VILLAGE OF MORTON GROVE

**PLAN COMMISSION PUBLIC HEARING**

**CASE:** PC 21-01

**Re:** **PC 21-01:** Tria Architecture, on behalf of Niles Township District for Special Education #807, requesting approval of a Special Use Permit for a "School, nonboarding" to allow the modification and expansion of an existing school in an R-2 Single Family Residence District in accordance with Section 12-4-2:C of the Village of Morton Grove Unified Development Code (Title 12), with variations to Section 12-2-2:B for number of accessory structures, Section 12-2-5:B for accessory structure setback, Section 12-2-6:G for open accessory parking spaces setback, Section 12-4-2:D for building height and impermeable lot coverage, and Chapter 12-11 for landscape requirements, for the property commonly known as 8701 Menard Avenue in Morton Grove, Illinois (10-20-207-020-0000, 10-20-207-021-0000, 10-20-212-018-0000)

**Figure 1**

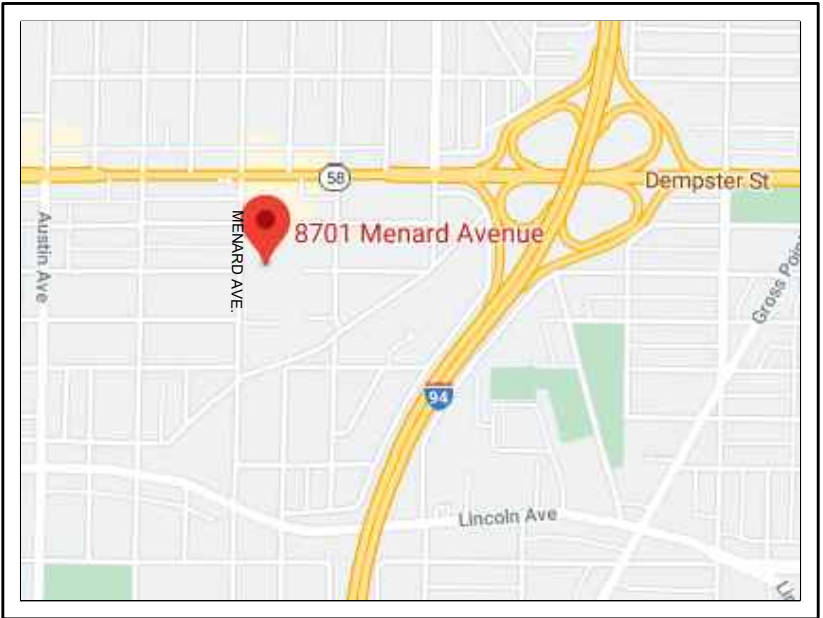
7. Existing Roadway System: Add Dempster Street to Figure 1 and/or describe relative location to site.
8. Existing Roadway System: Characterize traffic volumes, functional classification and land use of Menard, Capulina, Crain, and Carol.

PROJECT NUMBER	10-001
PROJECT NAME	DC
DRAWN BY	DC
ISSUED FOR VILLAGE REVIEW	08/02/2021
EXISTING AND PROPOSED SITE PLANS

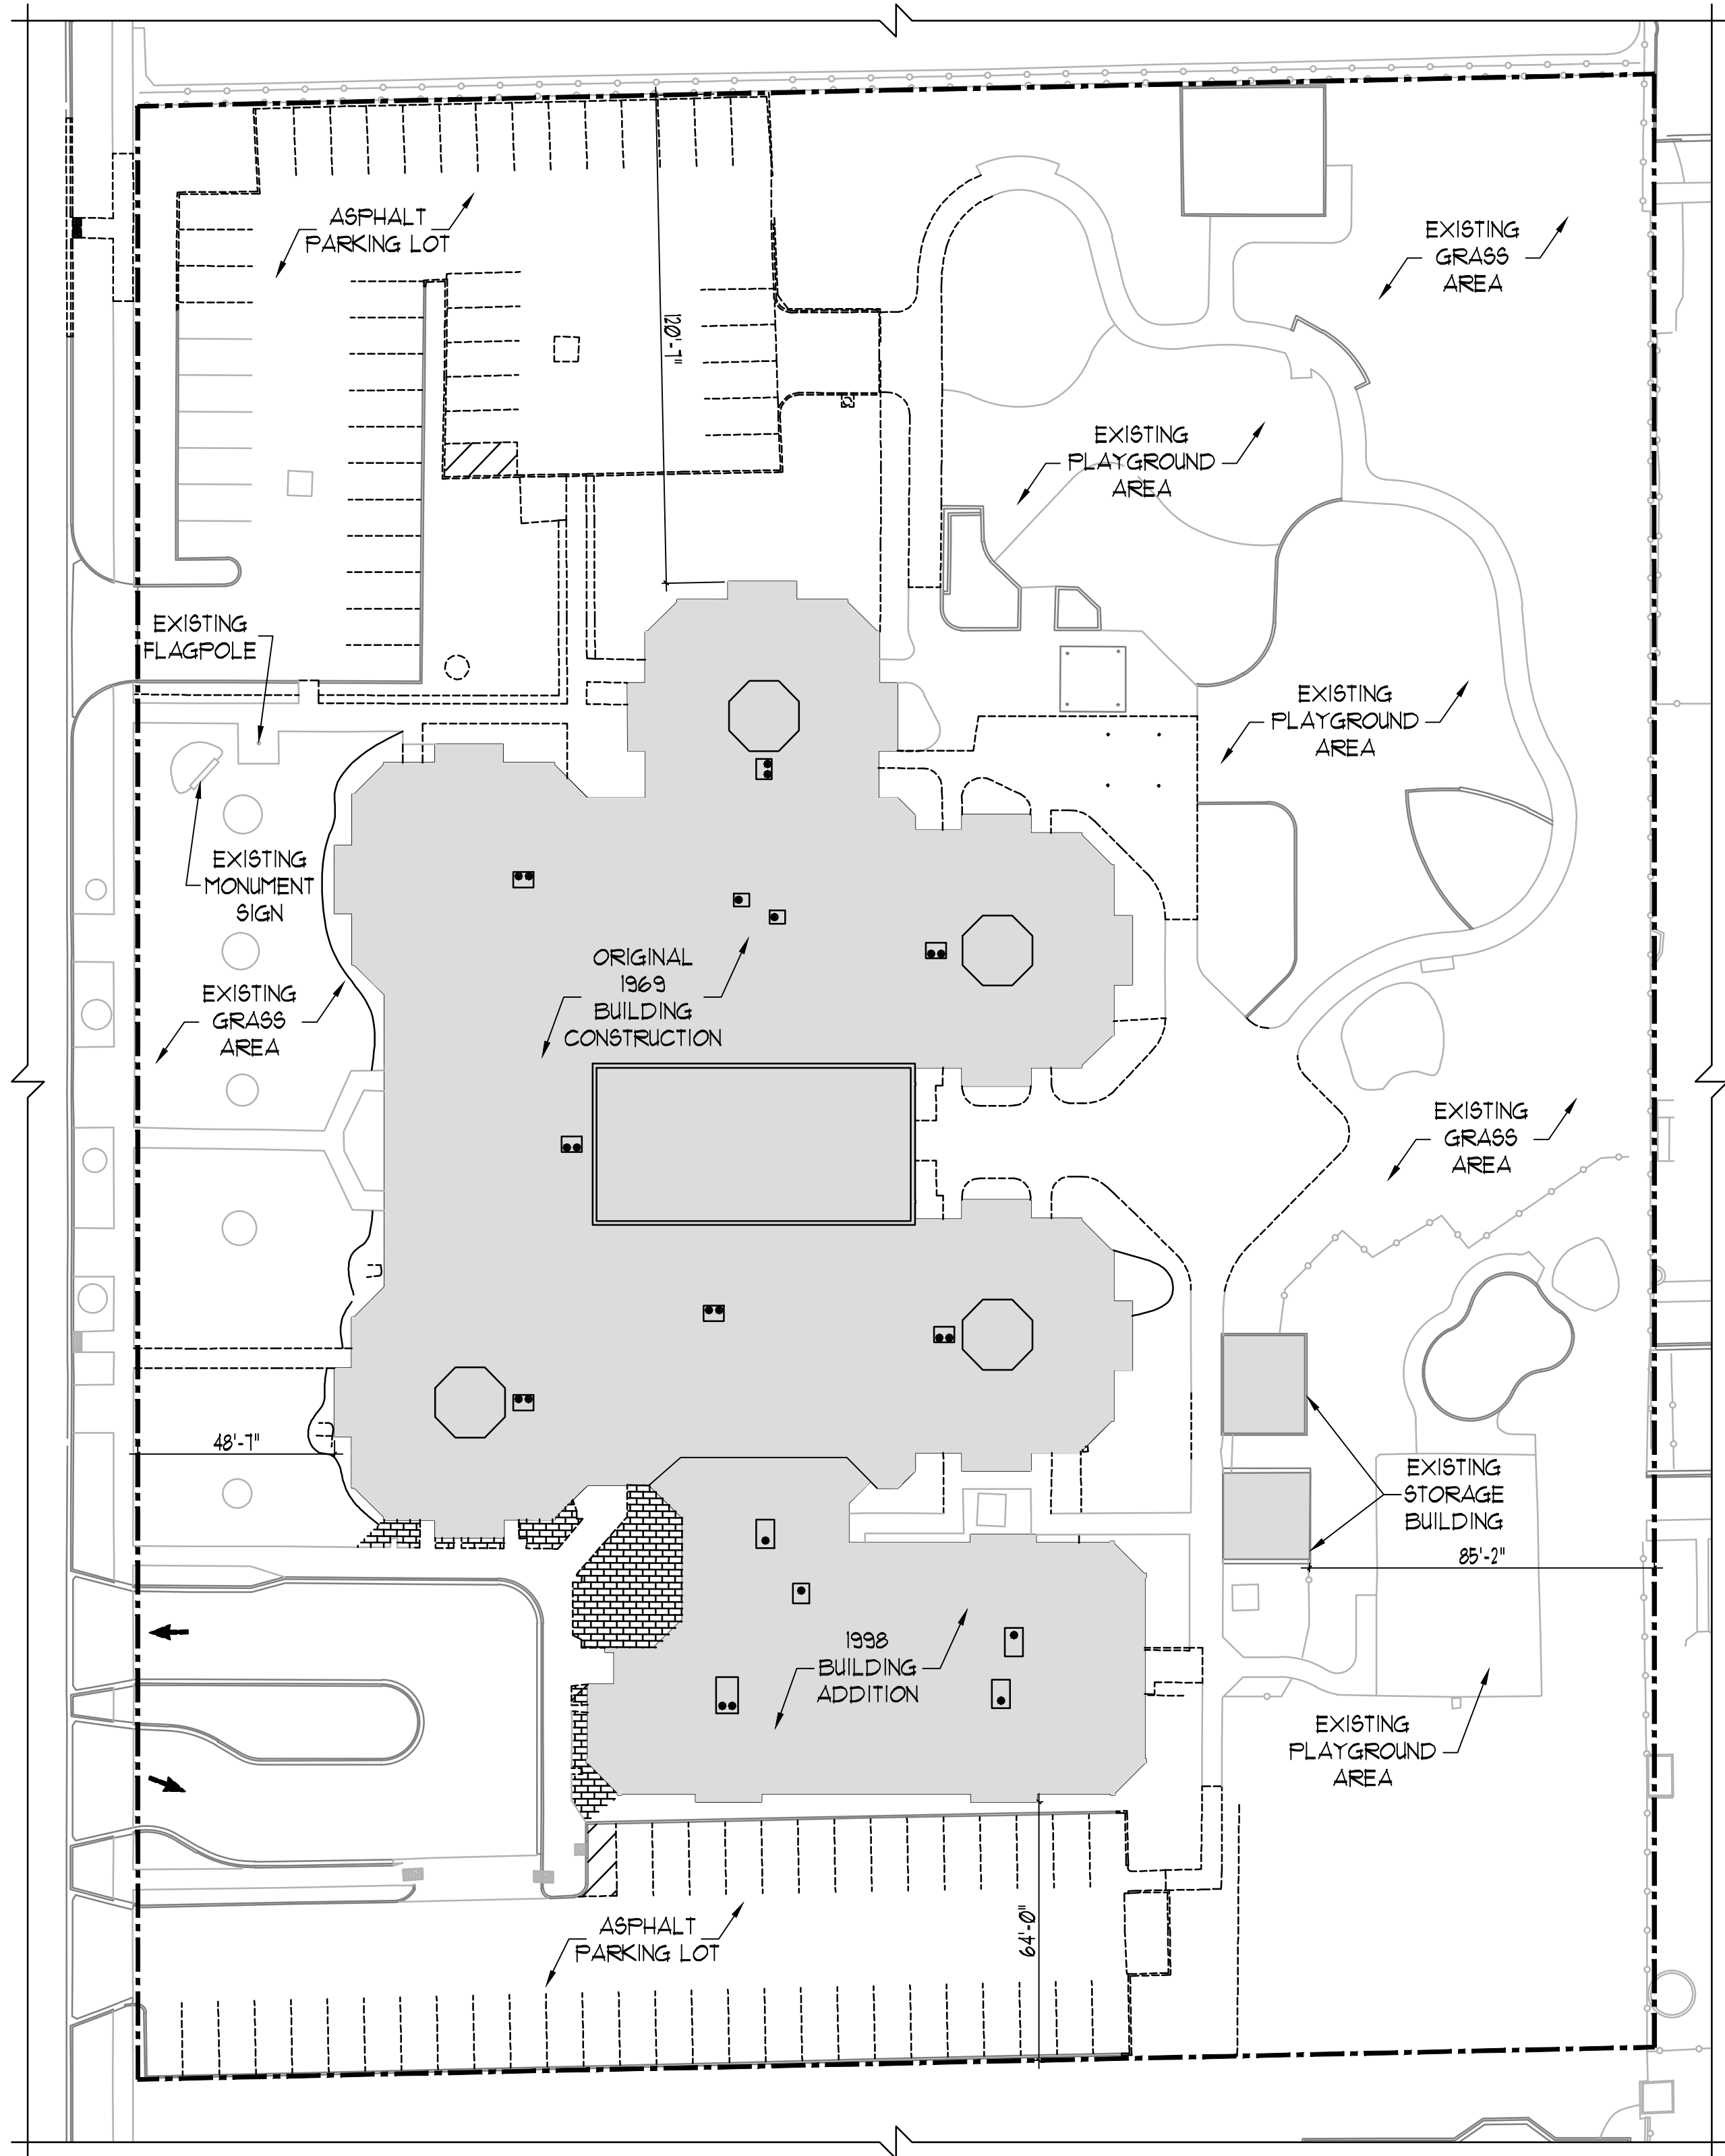
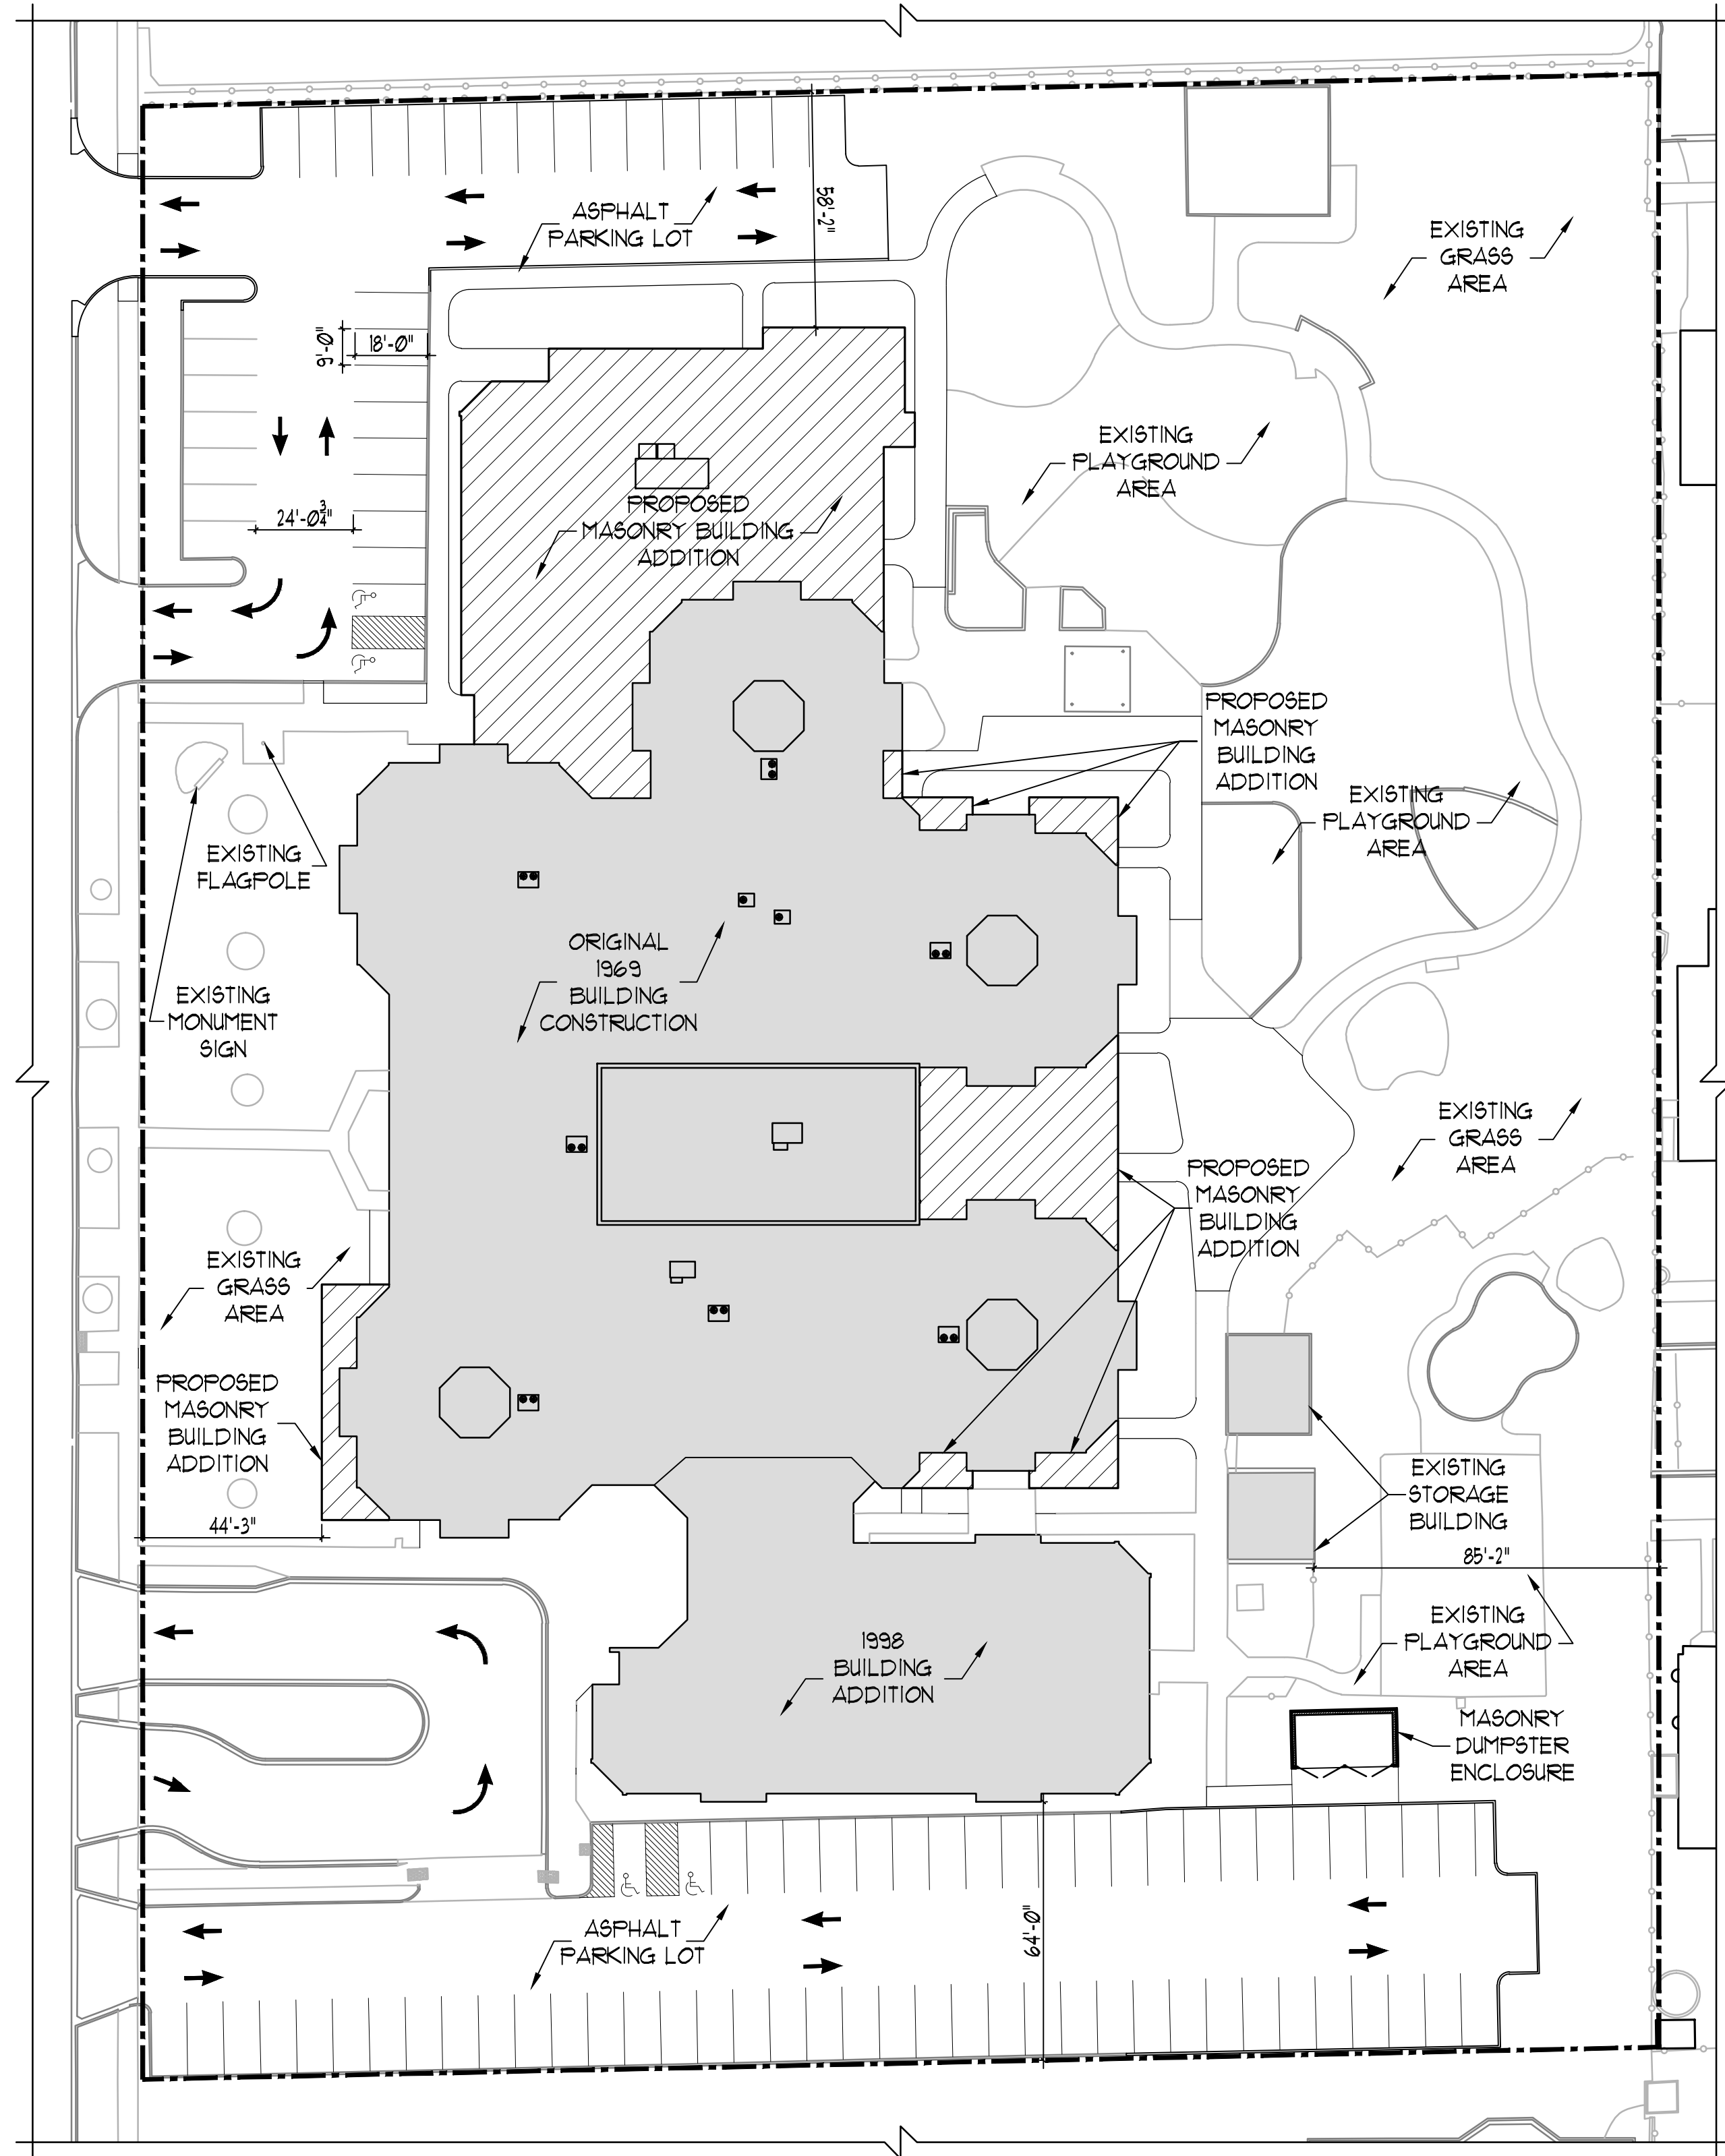
1. Building Height: The Applicant is requesting a waiver of five feet to allow a flat-roofed building height of 40 feet. The additional height will allow for the construction of a new gymnasium on the first floor, with a second story above the gym to contain administrative facilities. Gymnasiums typically require greater ceiling heights, and the construction of additional square footage above the gym is an efficient use of construction activity and budget. Due to the larger setbacks provided on the property, staff is supportive of the requested waiver.
2. Impermeable Lot Coverage: As presented, the proposed site plan meets the maximum impervious coverage ratio of 60%. However, as discussed later in the staff report, comments issued by the Fire Prevention Bureau Coordinator, Village Engineer, and Traffic Safety Commission recommend modification

to the north and south parking lots to provide passenger vehicle turn-around areas at their east ends. *Staff recommends including a requirement for parking lot turn-around areas as a condition of Special Use Permit approval. In order to allow the Applicant to meet this condition without eliminating proposed parking spaces, staff recommends preemptively authorizing a waiver to the impermeable lot coverage maximum, only to the extent needed to provide appropriate turn-around areas in the north and south parking lots. The design of the turn-around areas will be approved by the Village Engineer.*

5. Open Accessory Parking Spaces, Setback: This request for waiver legalizes existing conditions on the property. Open accessory parking spaces are required to be located a minimum of three feet from side and rear lot lines and are not a permitted encroachment of a front yard. The north and south parking lots are currently located less than three feet from the north and south side lot lines, and project into the property's front yard. This waiver will legalize the existing parking areas and allow them to be modified as presented.
